# **FINAL STATEMENT OF BASIS CORRECTIVE MEASURES SELECTION**

Bethlehem Steel (Tecumseh Redevelopment, Inc.)

Site Wide Remedial Elements, Water Courses  
and Groundwater

Site No. 915009

**Figure 4A- SWMU CAMU DESIGN**

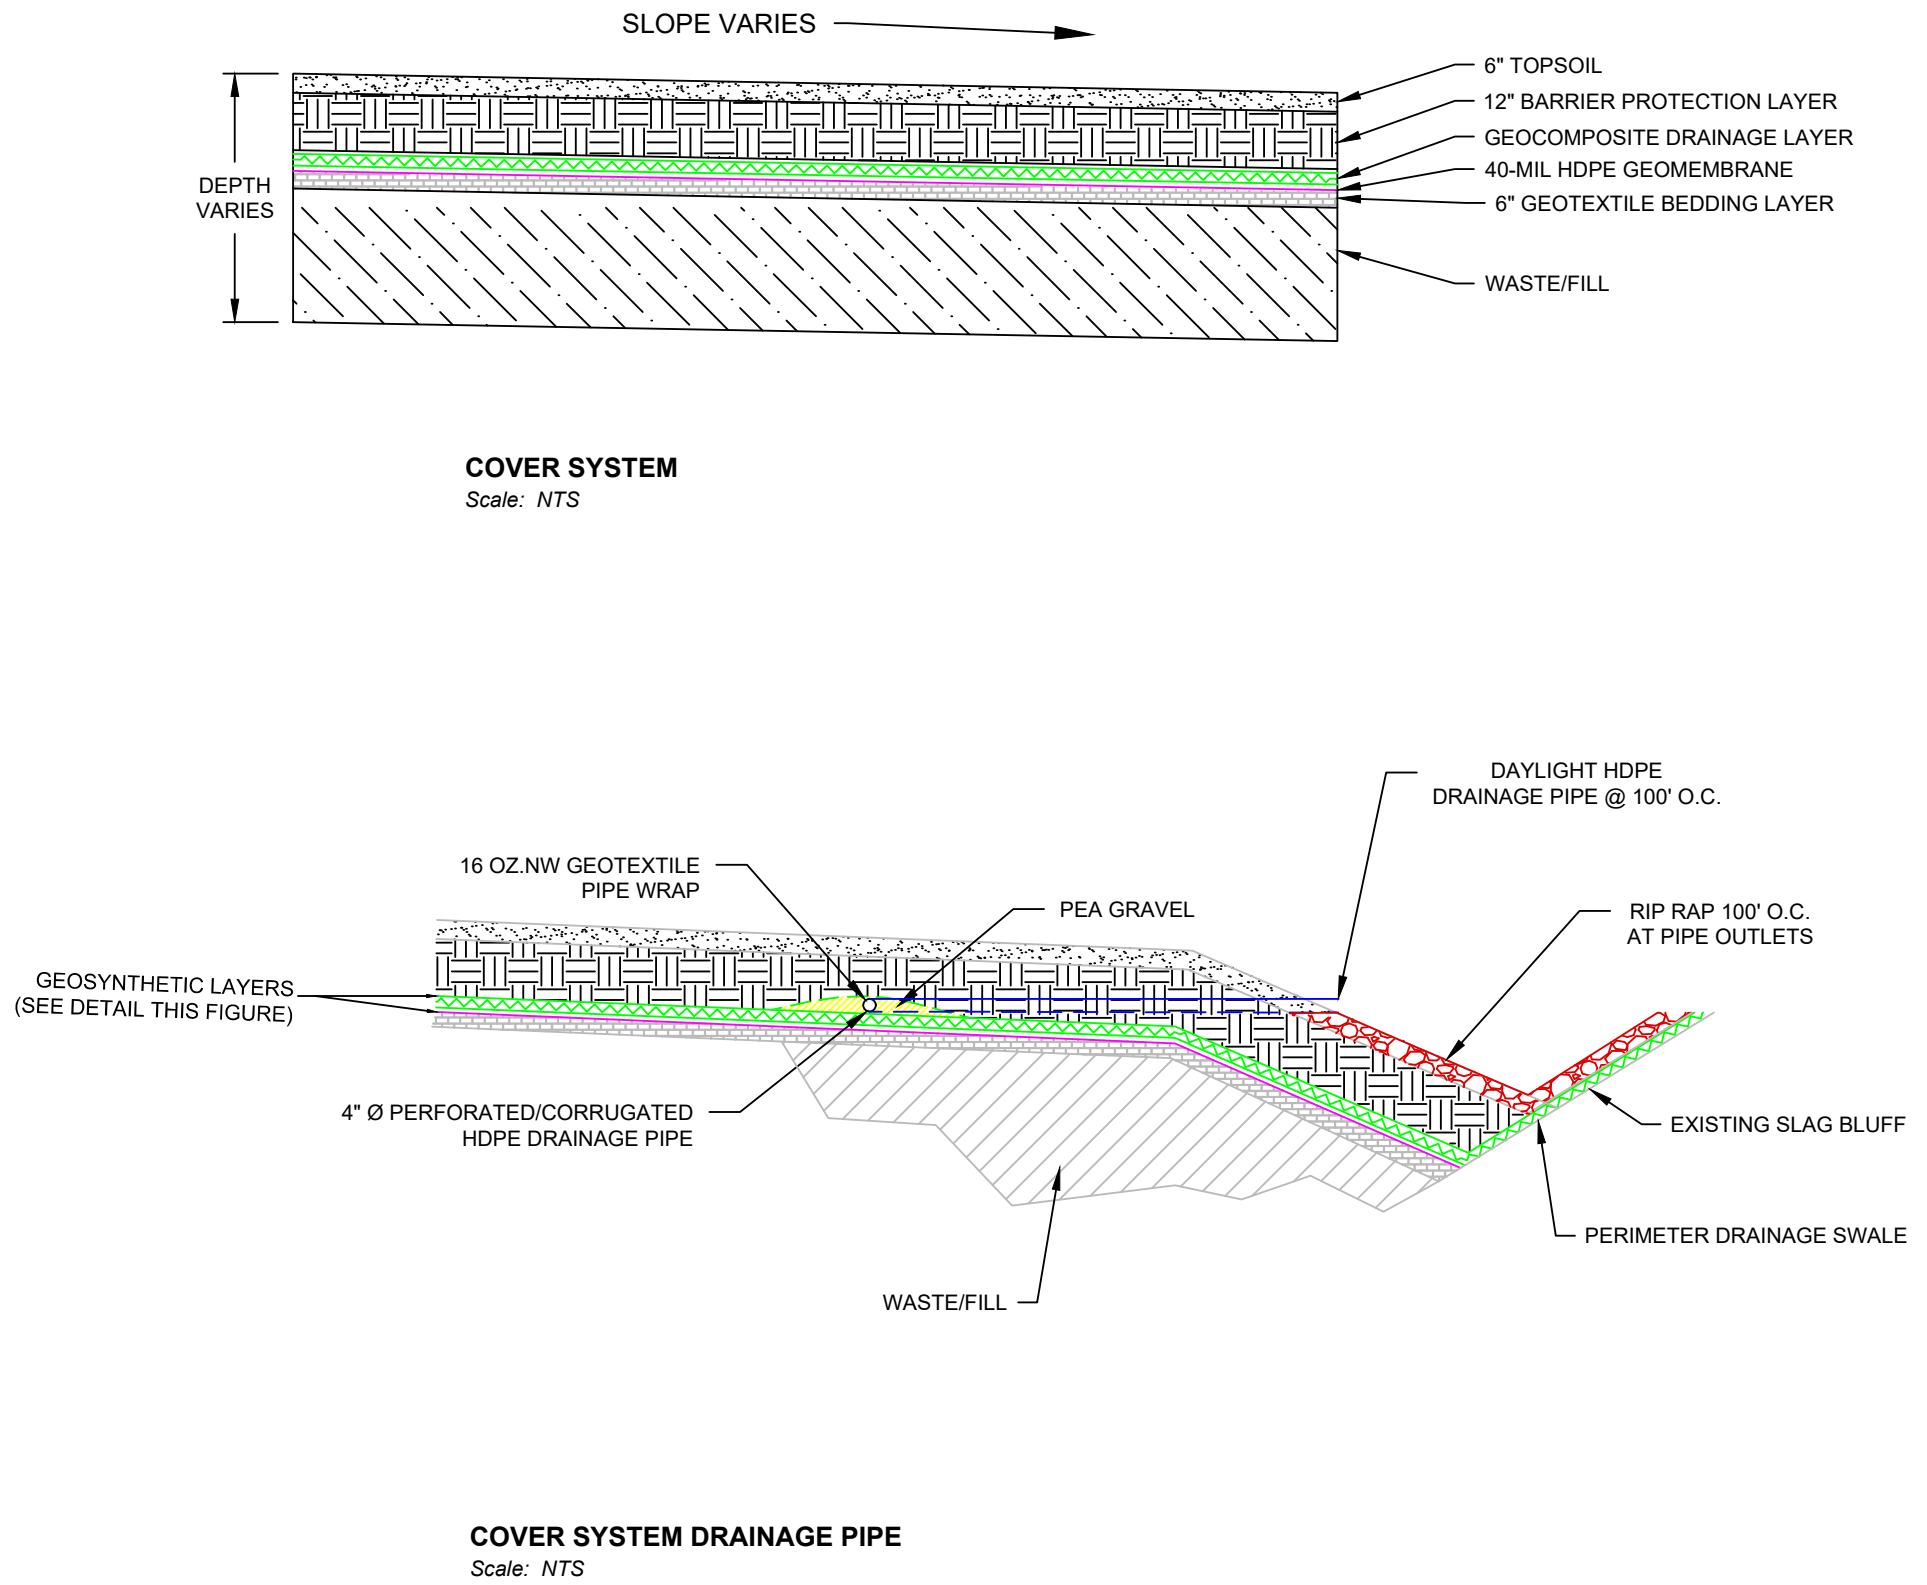
- The existing side slopes in SWMU S-7/S-20 are steeper than 2H:1V (Figure 4a). Either the side slopes will need to be flattened or special considerations will be needed during design to line the steep slopes. Further, the CAMU is to have only one cell and it may take time to fill the cell as the remedial work is performed. If the side slopes are not flattened, special considerations will be needed during design to place and maintain the 1' clean graded sand in place atop the bottom liner system.

- The proposed grading plan indicates top of CAMU perimeter berm at El. 630' (Figure 4a). Assuming base elevations as El. 620' to El. 625' (top of bottom liner system), the storage volume up to the top of perimeter berm is approximately 50,000-60,000 cubic yards. Considering the wide range for the volume of waste that will be consolidated in the CAMU, two very different final grade outcomes are possible as discussed below. CAMU design needs to maintain flexibility for both the outcomes.
